Re: **Kings Point CSP No. 1 / Final Plat No. 1 Response to Second Submission Review**
Application Number: **DA-1609-16**
Case Numbers: **2016-4012-00; 2016-3040-00**

SUMMARY OF KEY CONCEPTS FROM ALL DEPARTMENTS

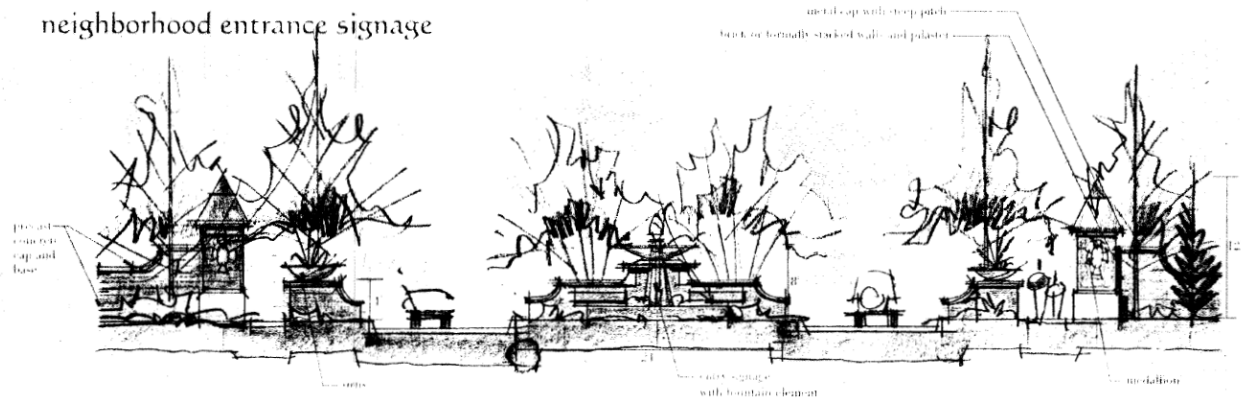
4J. Signage allowance for a neighborhood identification is 96 SF, a maximum of 6' tall (Section 146-1610). The FDP contains a general note of compliance with City Code, with additional schematic details on Sheet 11 of 20 (Case Number 2000-7007-01).

Response: The signage allowance was revised at the request of City Staff. The signage does comply with City of Aurora sign code.
